February 27, 2002

**Subject Hydrologic Review of Rainy Creek Restoration Project
Parker Property near Libby, MT**

Rainy Creek Typical As-Built Longitudinal Profile
Melvin and Lerah Parker Property
(note lack of steps and pools and riffle extension)

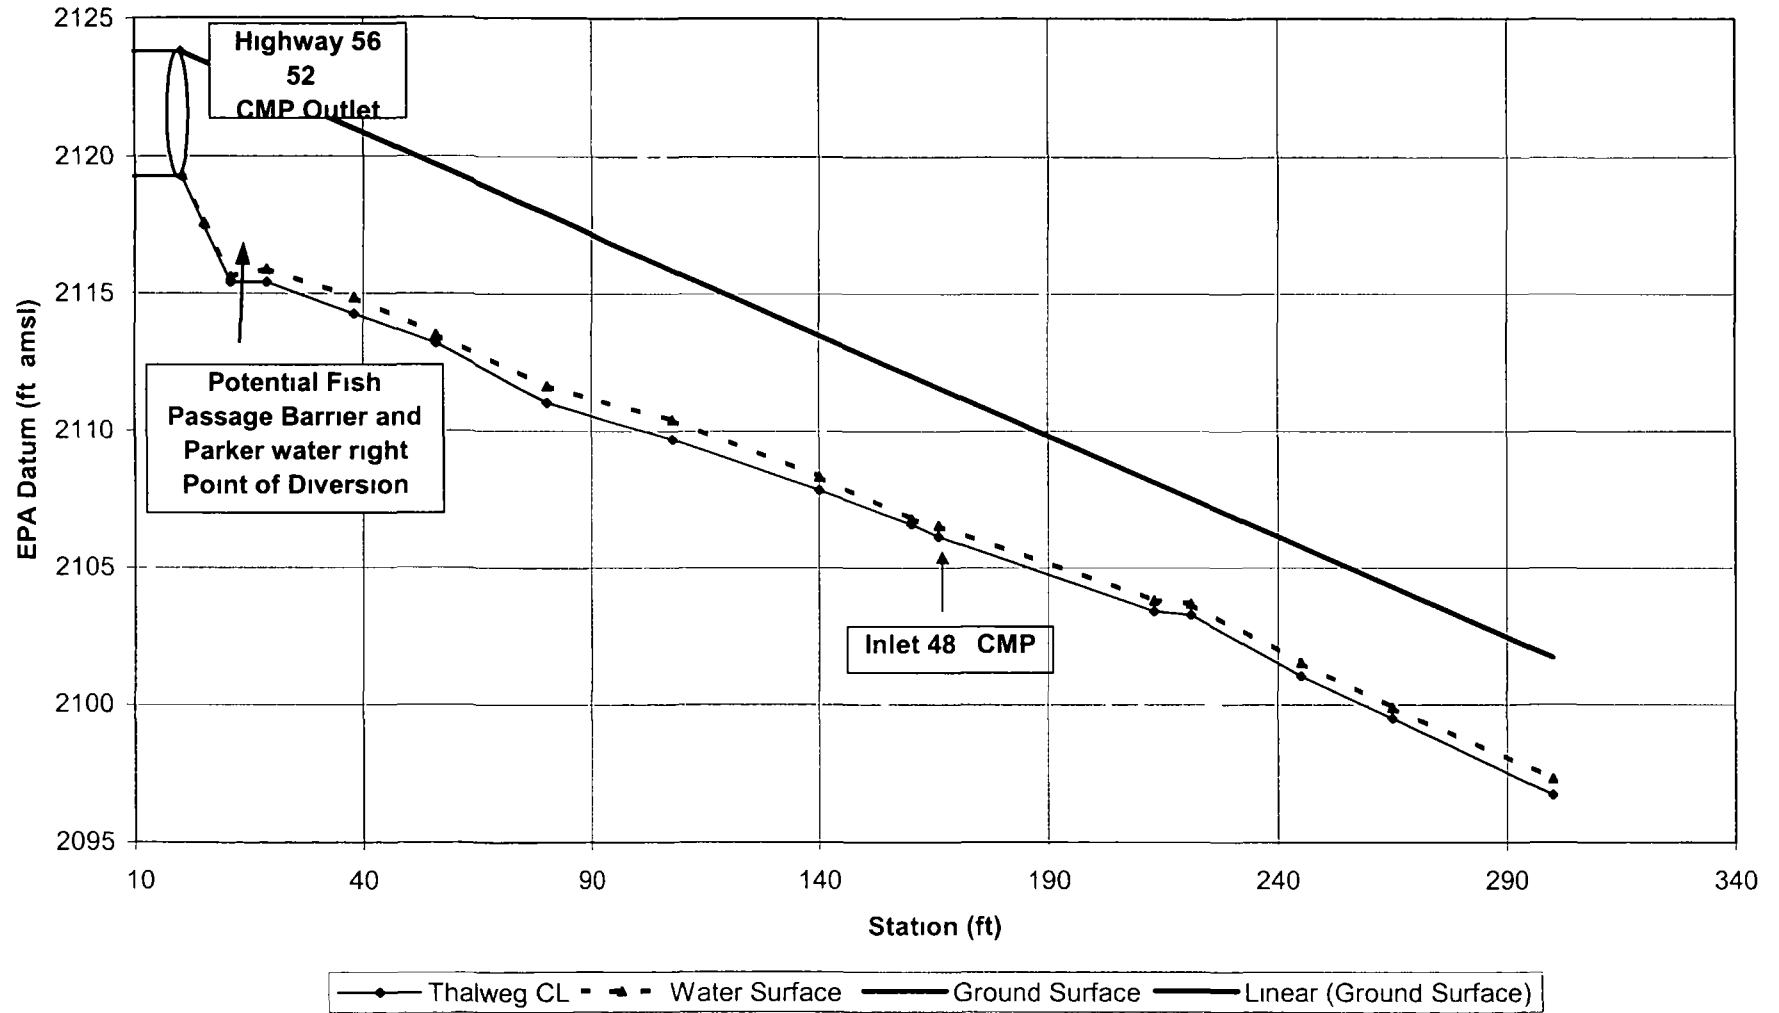
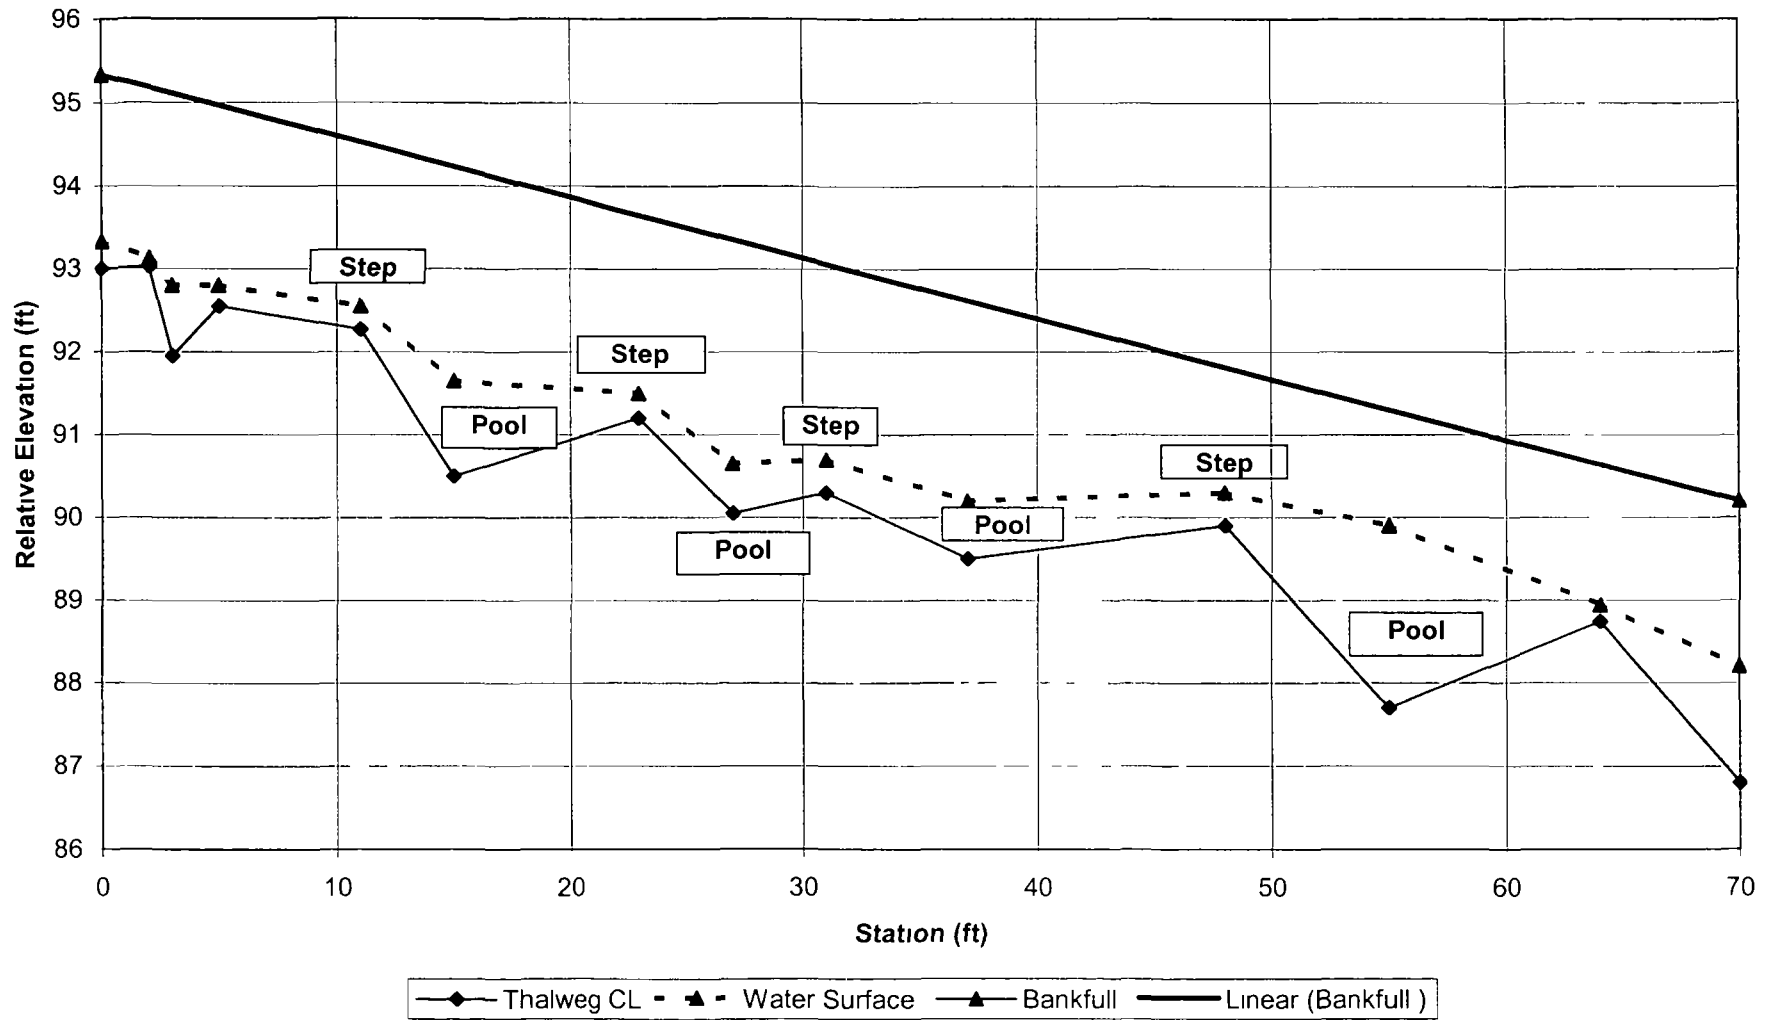
In the project area, average as-built channel slope is approximately 7.3% (0.73 ft/ft). Generally, when the average slope of the channel exceeds four percent, bedform profile transitions from a riffle-pool dominated channel to a step-pool channel. In step-pool systems such as the Rainy Creek restoration project area, step frequency is directly proportional to channel width and indirectly proportional to slope. As slope increases, the spacing between steps and pools decreases. Steps and pools are the primary grade control and energy dissipation mechanism in these types of streams and are vital to the vertical stability of the channel.

WCI collected longitudinal profile information from both the project area and the reference reach located upstream of Highway 56 (see appendix items). As previously noted, the reference reach displayed similar valley slope, and channel characteristics as the Parker property prior to restoration. As such, the reach can serve as a comparative tool for evaluating as-built channel dimensions of the restoration project. In the reference reach, steps and pools, with an average spacing of 12-ft, dominated the bedform profile. The ratio of steps to bankfull channel width ranged from 1.0–1.3, which is typical for these types of streams. Within the Parker restoration reach, and as displayed in the attached longitudinal profile, the channel was dominated by a homogenous extended high gradient riffle. The reach lacked steps and pools which function naturally to dissipate energy in the system and reduce boundary shear stress during high flows.

It is evident from the analysis of as-built channel cross-section dimensions and bed profile that the channel, as constructed, is undersized in terms of capacity and lacks the proper bedform features common for these types of streams and geomorphic setting. It is our professional opinion that if maintained in its current configuration, the potential for channel degradation (down cutting) is likely. If this were to occur, the bank placed riprap revetment would be highly susceptible to scour and entrainment. WCI recommends expanding the cross-sectional flow area and installing grade control weirs to maintain bed stability and the sediment transport competency of the project area (see Section 6.0 Conclusion and Recommendations).

- ◆ Install grade control structures (step weirs) to provide for energy dissipation and sediment transport,
- ◆ Modify sections (where needed) of the as-built channel to increase bankfull cross-sectional area,

Hydraulic Analysis of Rainy Creek Restoration Project Discharge = 97 CFS (Q2 0)

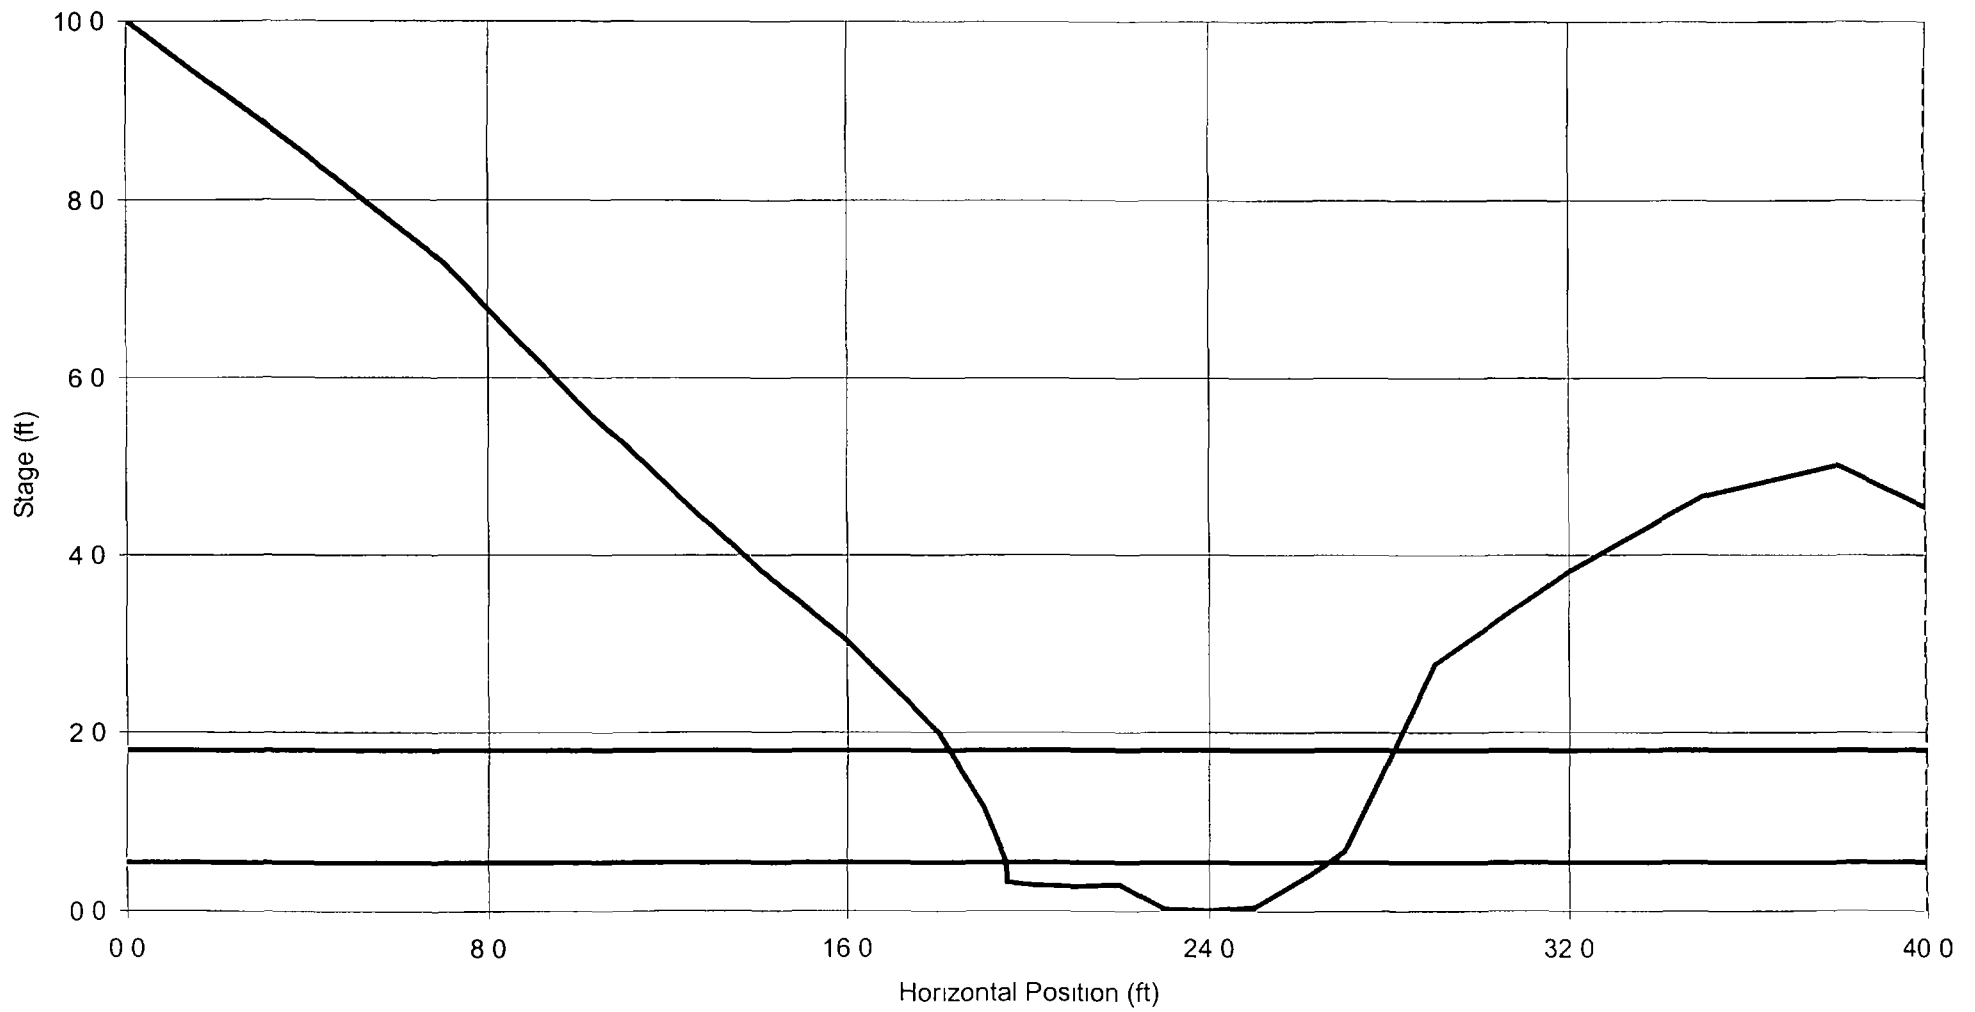
Based on the results of the USGS regional equations, it appears as though the riprap gradation and channel geometry was determined for less than the two-year recurrence interval discharge (see Table 1). As described in the following sections, consideration of flows greater than 90 cfs is integral to proper design of this project for several reasons, namely rip-rap sizing, vertical bed stability, and floodwater conveyance.

Channel design is based on sizing the active channel to the bankfull flow conditions (approximate 20 year recurrence interval discharge) and providing an adequate floodplain to accommodate flood events, including the 100-year discharge (Rosgen and Silvey, 1996 and Leopold et al 1964). Most channel dimensions including width and depth, are related to the bankfull discharge. It is evident from field measurement that the as-built cross section design on the Parker property deviates from the reference dimensions. In particular, the constructed bankfull cross-sectional area is approximately 43% less than the reference reach. This likely resulted from encroachment on the channel from riprap revetment. Additionally, the width and cross-sectional area of the floodplain is appreciably lower than necessary for this type of stream and flood series.

Hydraulic Analysis of Rainy Creek Restoration Project Discharge = 383 CFS (Q100)

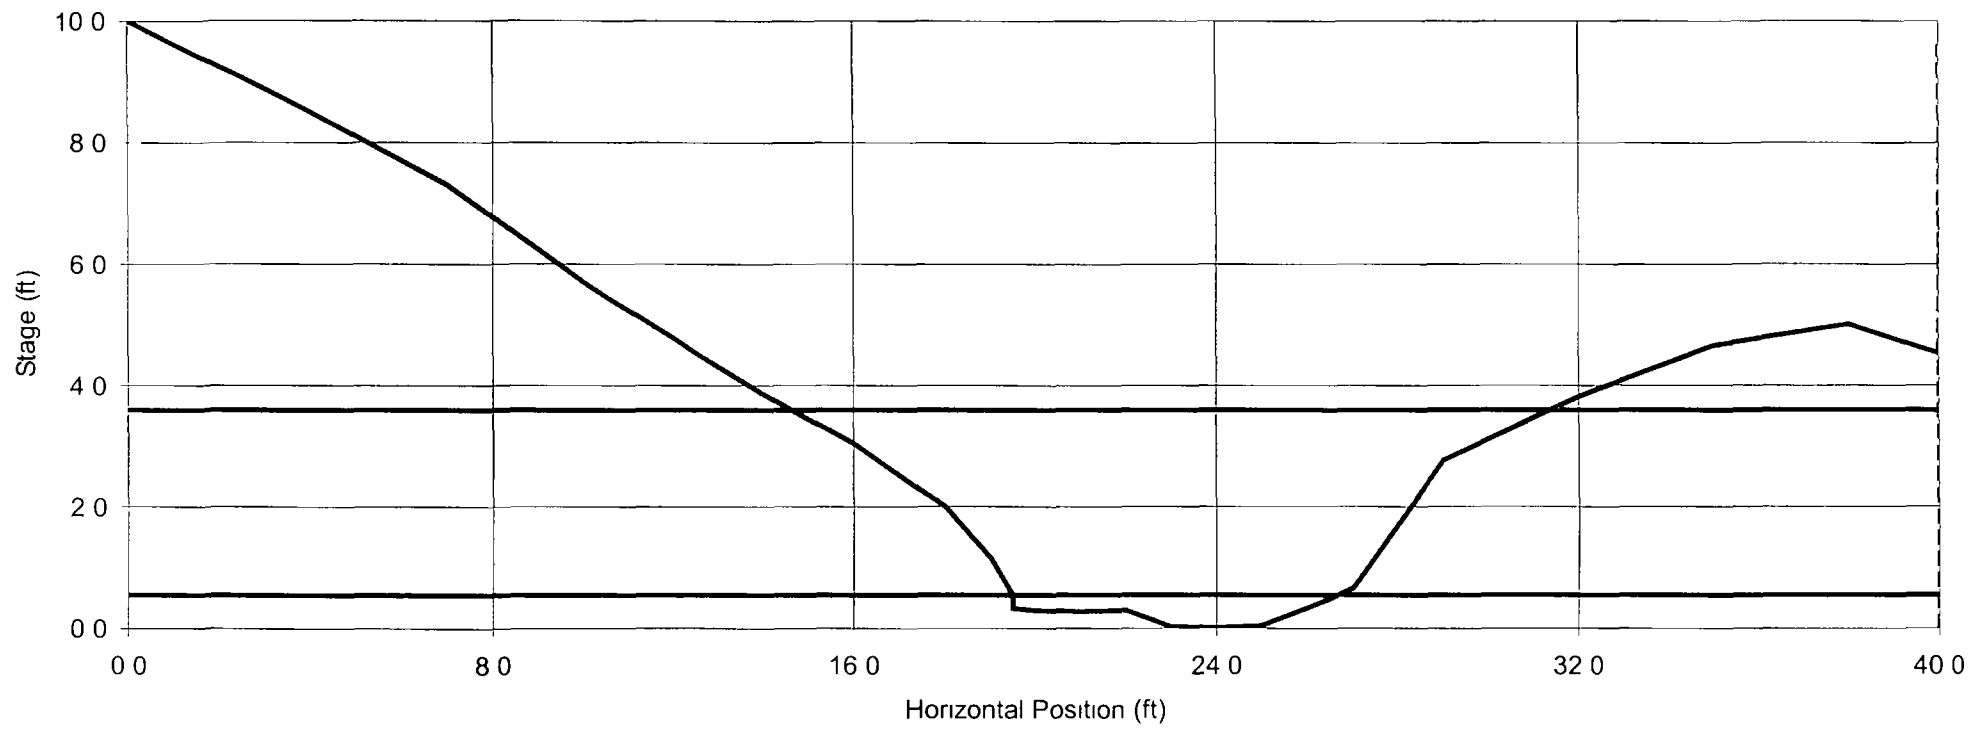
Referring to the MDOT Standard Specifications for Road and Bridge Construction, 1995 edition, the D₅₀ of MDOT Class II riprap is 1 32 ft or 16-inches As evident from Table 3, the median size of riprap placed on both bank is less than the recommended size of 1 32-ft Based on HEC-11 Guidelines for Riprap Sizing, the south bank gradation will be susceptible to scour at flows greater than the 10-year recurrence interval discharge (214 cfs)

STREAM NAME Rainy Creek
ID NUMBER North Bank Rip Rap Distribution Curve
DATE 2/27/2002
CREW JMM, Water Consulting, Inc

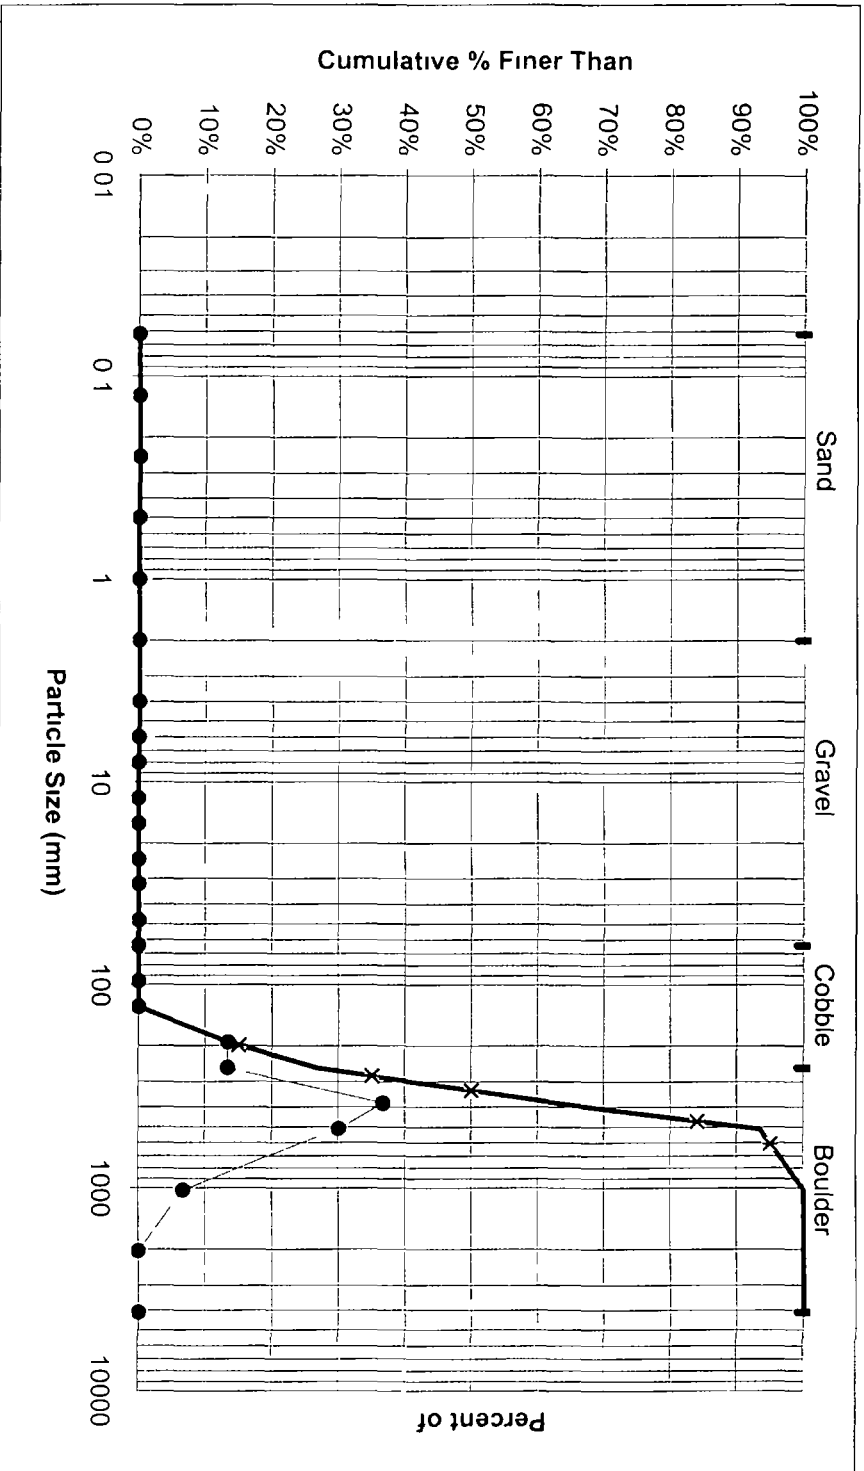
COMMENTS Distribution curve noting size of rip rap placed on north bank

- ◆ Excavate several excavation pits to determine the depth of the rip rap toe,
- ◆ Remove smaller size class rip-rap and add larger angular rock sized to MDOT Class II standards on both the north and south banks,

STREAM NAME Parker Property
ID NUMBER South Bank Rip Rap Distribution
DATE 2/27/2002
CREW JMM, Water Consulting, Inc

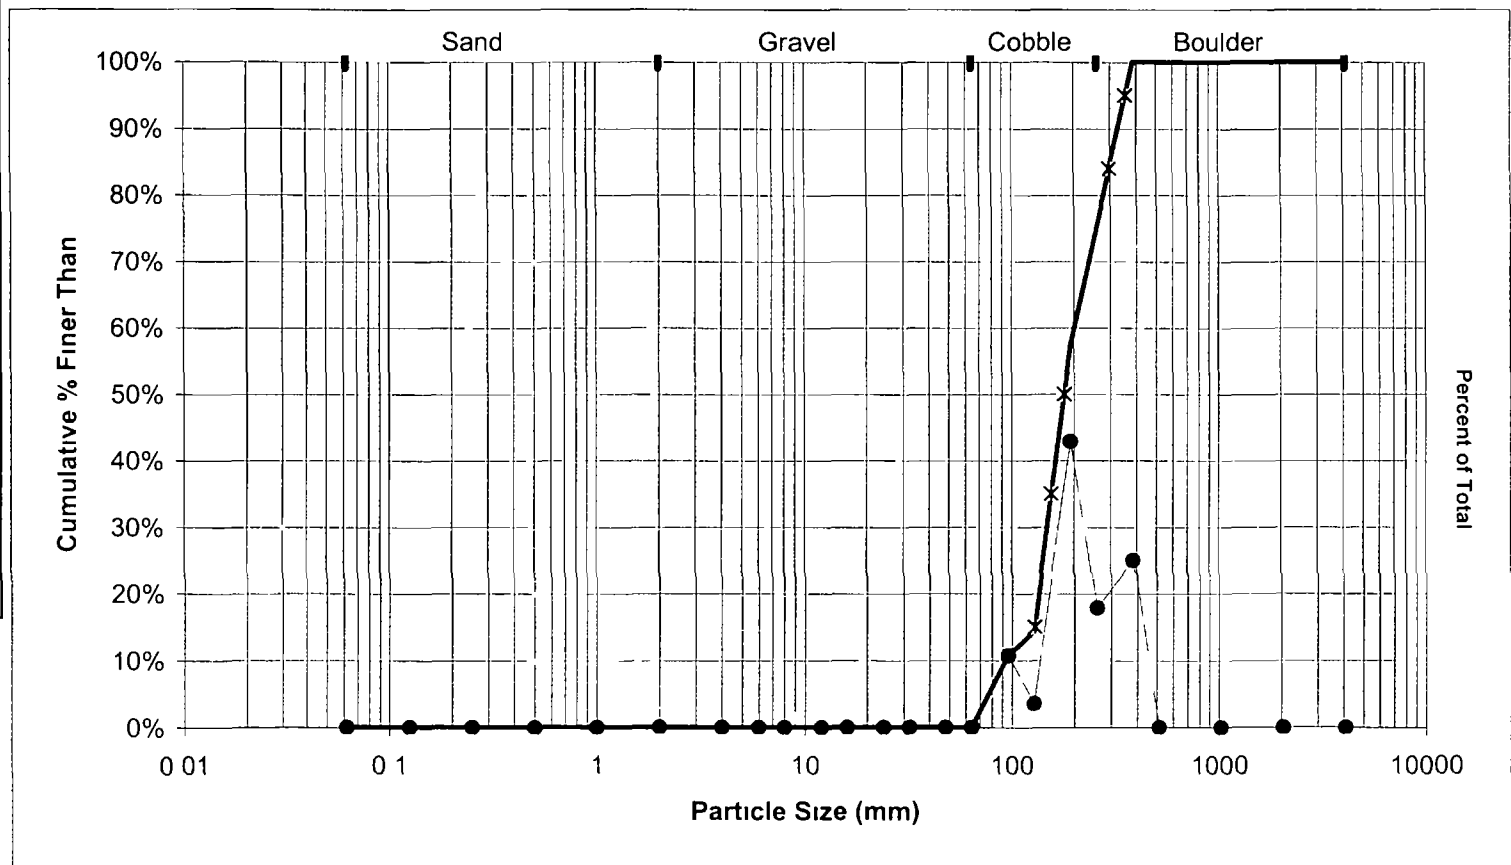
COMMENTS Distribution curve noting size of rip rap placed on south bank
